# 26 HILLBROW ROAD

## APPEAL TECHNICAL NOTE

Client/Project Owner	Stellar Hillbrow Ltd
Project	26 Hillbrow Road
Title of Document	Appeal Technical Note
Date	12/06/2020
Reference Number	109940
Number of Pages	21

**Figure 11. Road Collision Data (1999-2019)**

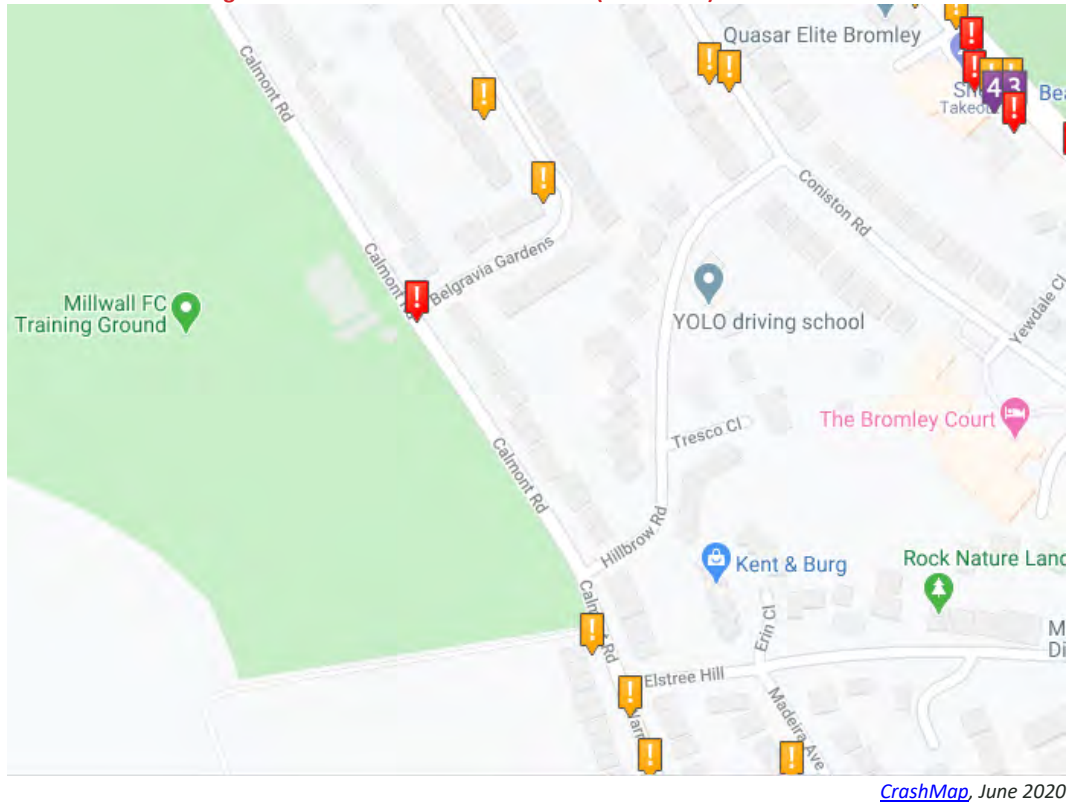
*“An intensification in use of Hillbrow Road by introducing additional residential units on the site would result in an increase in conflict between the different Road users of Hillbrow Road which would unacceptably increase safety implications, and reduce the already poor level of accessibility of Hillbrow Road, particularly given the poor condition of the road and the lack of footways” (Paragraph 73)*

*“This would result in potential conflict with vehicle manoeuvring that would significantly exacerbate existing accessibility and highway safety issues on Hillbrow Road” (Paragraph 96)*

*“The proposed development is therefore recommended for refusal, due to the significant harm identified in terms of highway safety” (Paragraph 163)*

*“... resulting in potential conflict with vehicle manoeuvring that would significantly further exacerbate existing prejudicial conditions to highway safety on Hillbrow Road” (Reason for Refusal 1)*

- 1.5.15 SYSTRA has undertaken a further review covering a greater time period and all years for which data is available. As shown in **Figure 11**, this has confirmed that, between 1999 and 2019, no road collisions have been recorded on Hillbrow Road, or at its junctions with Coniston Road and Calmont Road.

- 1.5.16 It is therefore considered that there is no evidence to suggest there are existing highway safety issues on Hillbrow Road and that the road currently operates in safe manner. There are no material existing road safety issues that would be exacerbated as a result of the trips forecast to be generated by the Proposed Development (as set out in **Section 1.6** of this Technical Note and **Section 5** of the Transport Assessment). These trips would not result in conflict between different road users that would result in unacceptable implications to safety.
